# Car Stereo Service Bulletin

**Model:** XR-7150/7180/7200/7280/7400

**No. 175**

**Subject:** Wow Or No Rotation

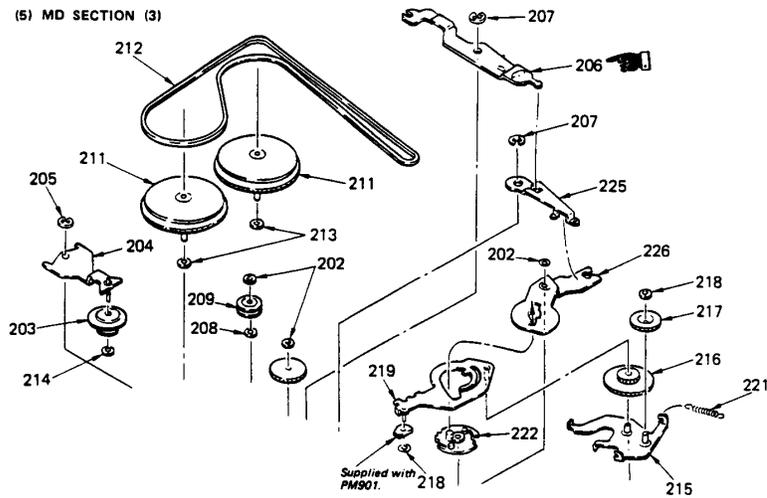
If there is either wow or no rotation due to the falling off of the belt (Ref. No. 212) from the Midway Pulley (Ref. No. 209), perform the following procedure.

**Solution:** If this symptom occurs, please change the Power Arm with an improved one, which includes a pin to avoid the falling off of the belt.

Ref. No.	Description	Part Number	
		Former	New
206	Power Arm Assembly	3-344-107-01	X-3344-139-1
